UNITED STATES PATENT AND TRADEMARK OFFICE

APPLICATION NO.	FILING DATE	FIRST NAMED INVENTOR	ATTORNEY DOCKET NO.	CONFIRMATION NO.
09/910,960	07/24/2001	Ola Olofsson	TPP 30887CIP2	4841

Office Action Summary

DETAILED ACTION

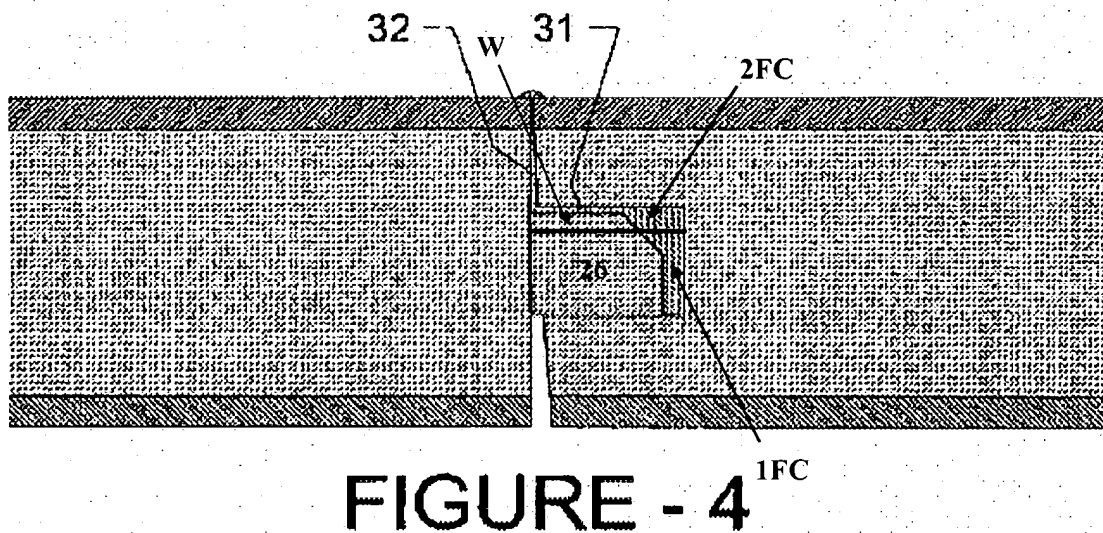
Claims 3-7, 9-15, 18-25 are rejected under 35 U.S.C. 103(a) as being unpatentable over Nelson (US 5,618,602) (see marked-up figure below) in view of Martensson (WO96/27721).

Claim 7 (Independent). Nelson shows and discloses a guiding means at a joint between adjacent boards 10, said boards comprising an upper surface 12, and a core 13, and bounded by edges, at least one of said edges comprising a groove 16 or a tenon 26, said tenon 26 comprising a plurality of guiding wedges **W** (comprised of portions of 27 and 30) wherein the tenon 26 has an angled distal surface and at least one of said guiding wedges **W** is positioned between said angled distal surface and the core 13, wherein a fitting clearance between the tenon 26 of a first of said boards and a groove 16 of the adjacent board includes a first fitting clearance 1FC, the first fitting clearance 1FC being bounded by a distal end 29 of the tenon 26 and a proximal part 19 of the groove 16, and a second, guiding, fitting clearance 2FC which second, guiding, fitting

clearance **2FC** being bounded by, on at least one side, said guiding wedge **W**, whereby the first fitting clearance **1FC** comprises the main part of the fit and the second, guiding, fitting, clearance **2FC** comprises a smaller part of the fit, and said guiding wedge **W** comprises a distal angled surface **30** and a section **27** extending from said distal angled surface **30** of said guiding wedge to said core **13** (see figures 1-8, *especially* figure 1 and annotated figure 4 below). Nelson fails to disclose that the at least one guiding wedge comprises a plurality of guiding wedges arranged perpendicular to the extension of the joint. Martensson, teaches guiding wedges **9** arranged perpendicular to the extension of a joint in order to strengthen the joint connection. In any event, duplicating the components of a prior art device is a design consideration within the skill of the art. In re Harza, 274 F.2d 669, 124 USPQ 378 (CCPA 1960). Therefore, it would have been obvious to one having ordinary skill in the art at the time the invention was made to include a *plurality* of guiding wedges arranged perpendicular to the extension of the joint, as taught by Martensson, in order to strengthen the joint and further since duplication of components is within the ordinary skill of the art.
